Truss Fabricator: **Anderson Truss Company**
Job Identification: **Repair 12-198pb (Repair 12-198pb-)**
Truss Count: **1**
Model Code: **Florida Building Code 2010**
Truss Criteria: **FBC2010Res/TPI-2007(STD)**
Engineering Software: **Alpine Software, Version 12.02.**
Structural Engineer of Record: **The identity of the structural EOR did not exist as of the seal date per section 61G15-31.003(5a) of the FAC**
Address: **Roof - 37.0 PSF @ 1.25 Duration**
Minimum Design Loads: **Floor - N/A**
Wind - 120 MPH ASCE 7-10 -Closed

Revised Trusses

TRUSS REPAIR

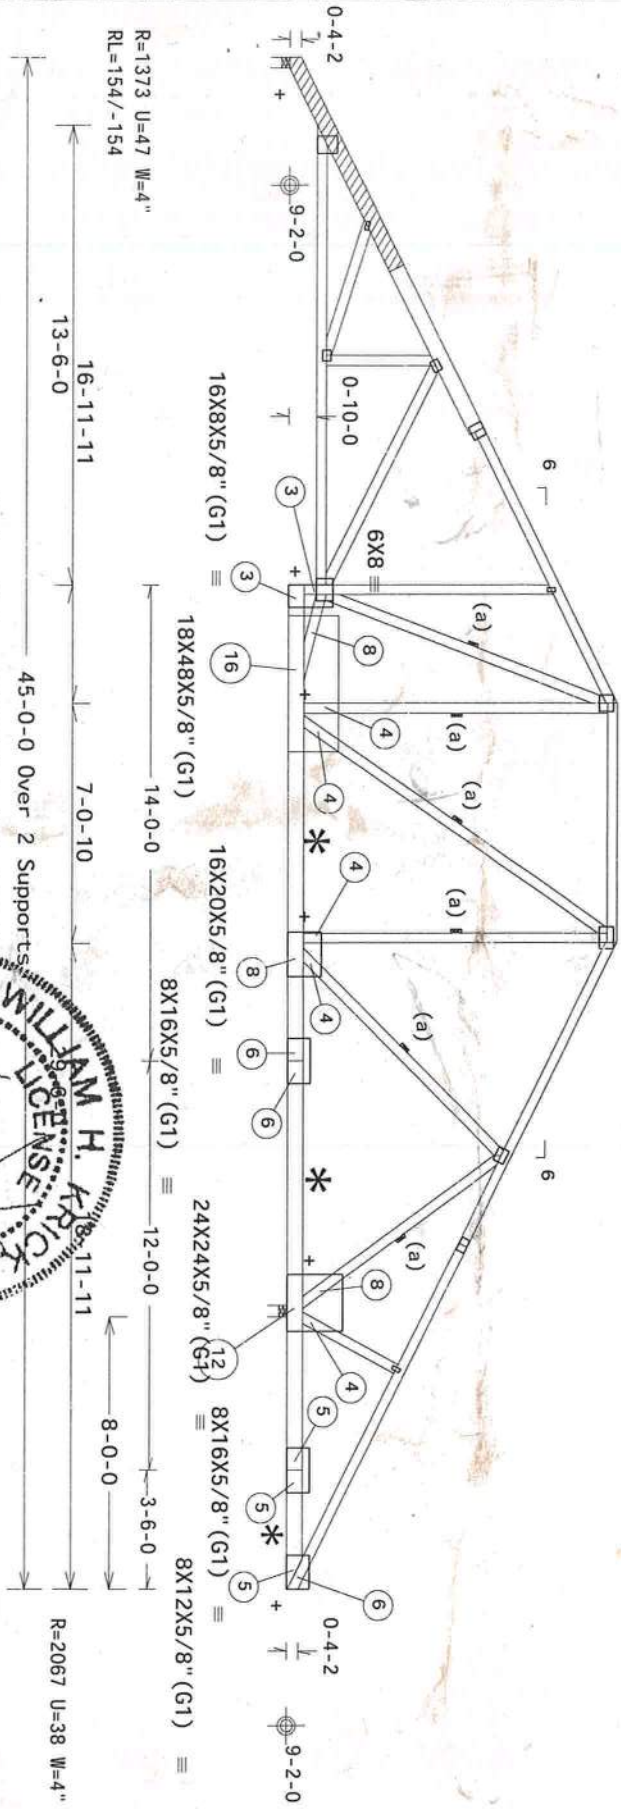
REPAIR TO CHANGE EXTERIOR GEOMETRY OF TRUSS, BEARING ELEVATION WENT FROM 9-0-0 TO 9-2-0 AS SHOWN.

FIELD REPAIR MUST COMPLY WITH ALPINE DESIGNS AND SPECIFICATIONS. REFER TO DRAWING HCURSR487 12234014 FOR LUMBER, PLATES AND OTHER DATA NOT GIVEN HERE.

+ USE A SHARP METAL CUTTING SAW BLADE TO CAREFULLY REMOVE UNWANTED MATERIAL FROM THE TRUSS AS SHOWN DASHED. REMAINING PORTIONS OF TRUSS MUST BE FREE FROM DAMAGE.

* ONE (1) 2x6x(CUT TO FIT) SP #2 12A OR BETTER. ATTACH WITH GUSSET PLATES (G1) AS SHOWN AND DIRECTED.

- (G1) Gusset Plates are 5/8" APA STRUCTURAL I RATED SHEATHING, 40/20, EXP 1. Apply gusset to each face of truss and attach with evenly distributed 0.131"x2.5" Nails specified in circles. Hatched lines indicate portions on gussets protruding outside of the perimeter of the truss that may be trimmed flush with the truss profile. Minimum Nail/Screw Spacing Requirements Based on ANSI/AF&PA NDS-2001: End Distance 2-1/8" Edge Distance 3/4" Spacing Between Rows 3/4" Spacing in a Row 2-1/8" Maximum Number of Rows for Member Size:
 - 2x4 3 Rows
 - 2x6 6 Rows
- (a) Continuous lateral bracing equally spaced on member.
- (2) 2x6x6-11-12 SP M-26 scabs at left end. Attach one scab to each outer face of chord with: 0.128"x3" min. nails @ 8" OC, Plus additional nail clusters at: BRG.: (4), heel: (6), 1st panel point: (3).
